BUCKLAND PARISH COUNCIL

MO/2026/01018: Demolition of East Annexe, Headley Wing and part of main building and erection of extension to main building including erection of replacement subterranean extensions to provide additional hotel accommodation (Use Class C1), erection of detached ancillary events space, spa and 4 No. lodges, 5 No. treehouses, car and cycle parking, access improvements, landscaping and other associated works at Hartsfield Manor, Sandy Lane, Betchworth, RH3 7AA

Appendix

Drawing Title:
Proposed
Site Plan - Roof

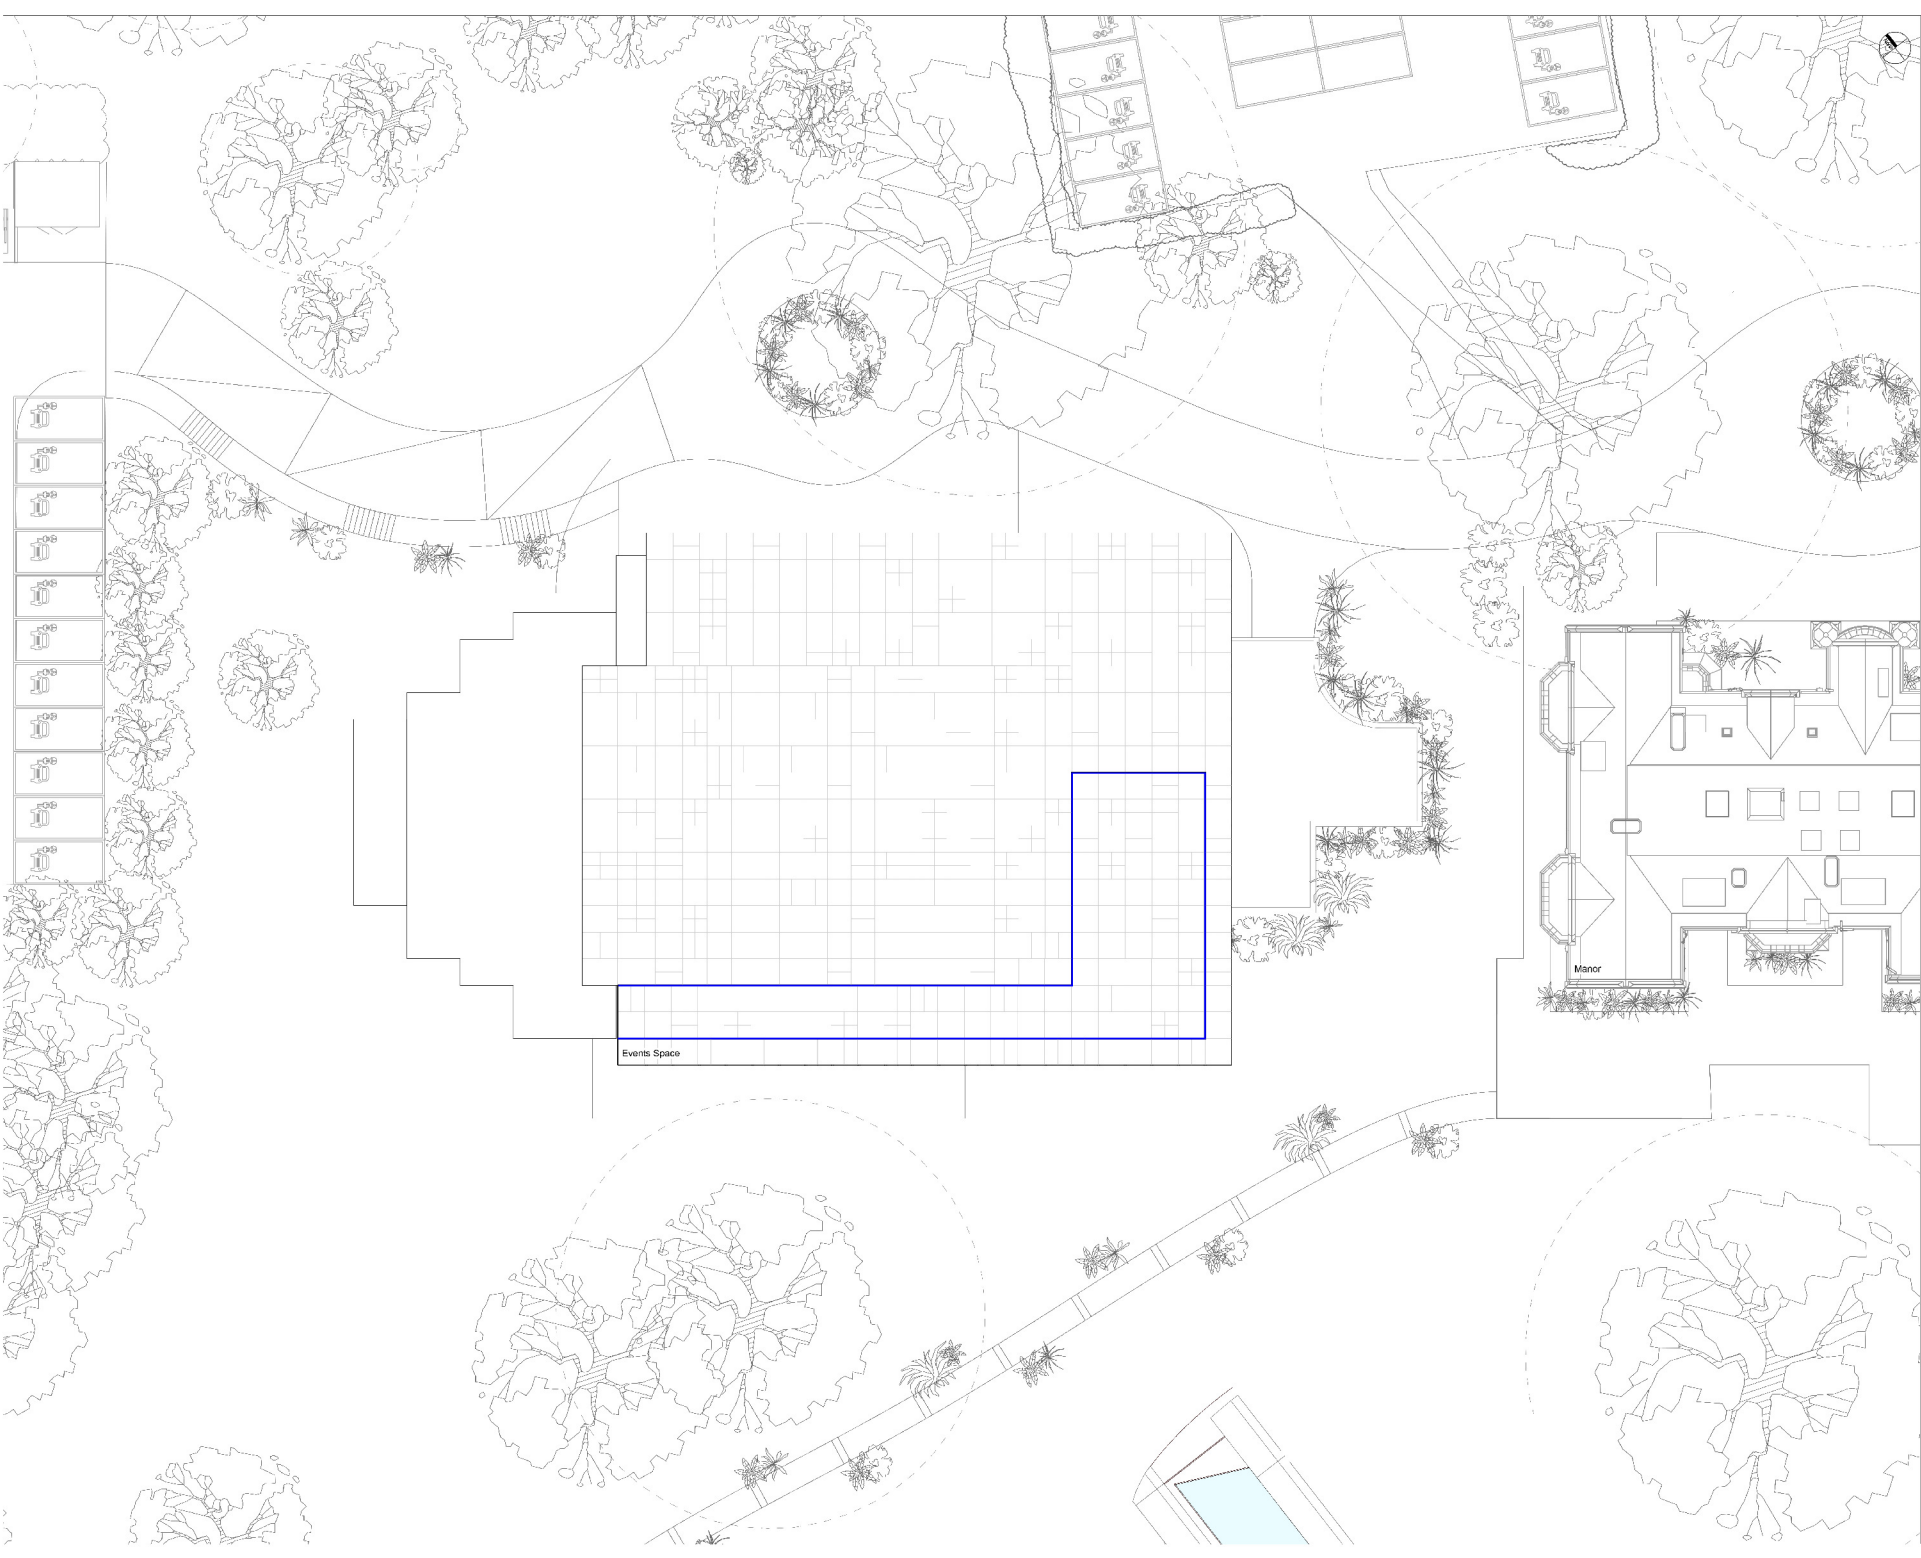
Council notes that the claims are made to the effect that noise disturbance will be low given the proposed design of the event space and is keen to ensure that the proposed communal external areas are limited to daylight use to remove any need for external lighting and ensure noise from these areas does not adversely impact the amenity of residents living on Old Road, Sandy Lane and Dungates Lane in Buckland and those living on Old Reigate Road, The Street and Wonham Lane in Betchworth.

The project team recently shared an additional drawing, intended to show the extent of the rooftop observation area proposed for the event space. The email accompanying the drawing advised "As shown on the drawing, the roof platform is enclosed by glass balustrades around its perimeter. The attached plan identifies the extent of the accessible roof area available to guests. There are currently no proposals for furniture or other permanent features on the roof platform itself. Lighting is expected to be limited to low-level spot lighting for safety and way finding purposes in with the wider lighting strategy. [...] access would be via the ramped walkway and the roof platform would operate as an ancillary part of the event venue rather than as a stand alone destination in its own right."

Council asks MVDC to require the applicant to make such changes to the application drawings as are necessary to ensure they are consistent with the intended use of these areas to facilitate a full and proper assessment of the proposals and allow appropriate conditions to be attached to any permission granted.
